APPLICATION NO.	FILING DATE	FIRST NAMED INVENTOR	ATTORNEY DOCKET NO.	CONFIRMATION NO.
10/692,828	10/24/2003	Daniel James Dickinson	TE9A	9259

Office Action Summary	Application No.	Applicant(s)	
	10/692,828	DICKINSON ET AL.	
	Examiner Ruth C. Rodriguez	Art Unit 3677

DETAILED ACTION

FIGURE 4

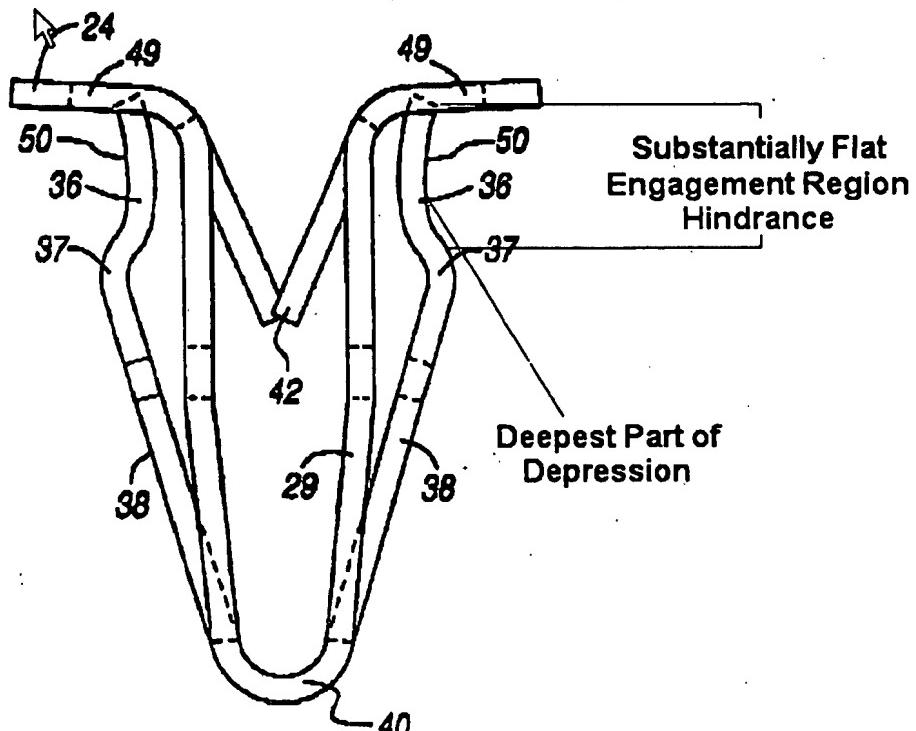
The hindrance portion comprises only one to three ripples having the form of a depression (recess provided between 37,137 and the free end of the spring 28,128) on the hindrance portion. The depression has a deepest part, a front side, a back side and a width (Figs. 1-8). The hindrance portion has a surface (between 37,137 and the free end of the spring 28,128) wherein the depth of each ripple is the distance between the surface of the hindrance and the deepest part of the respective ripple (Figs. 1-21).

- The hindrance portion comprises ripples (defined by the recess between the peak 37 and the free end 26 the spring 34 and defined by the recess between 137 and the free bend 126 of the spring). Each ripple has the form of a depression (recess between the peak 37 and the free end 26 the spring 34 or the recess between 137 and the free bend 126 of the spring). The depression has a deepest part, a front side, a back side and a width (Figs. 1-21). The hindrance portion has a surface and comprises not more than three ripples wherein the depth of each ripple is the distance between the surface of the hindrance and the deepest part of the respective ripple (Figs. 1-21).

5. The Applicant argues that Osterland has a concave engaging surface 50 that was identified as the hindrance portion and depression without any distinction and that a mere bend can not be considered a depression. This argument fails to persuade. The Examiner has revised the rejection in order to make clear that the hindrance is located between the peak 37 and the free end of each spring. This hindrance comprises a depression or bent or concave engaging surface 50 whose side near the peak serves to

retain the clip in engagement with the slot of the second part or member as required by the claims and the surface of the concave engaging surface defines a ripple as seen in the figures. Especially, since the claims only require a depression and a concave engaging surface when taken with respect to its outer limits (the free end and the peak) do form a depression regardless of whether it is a mere bent or not. Therefore, Osterland meets these claim limitations.
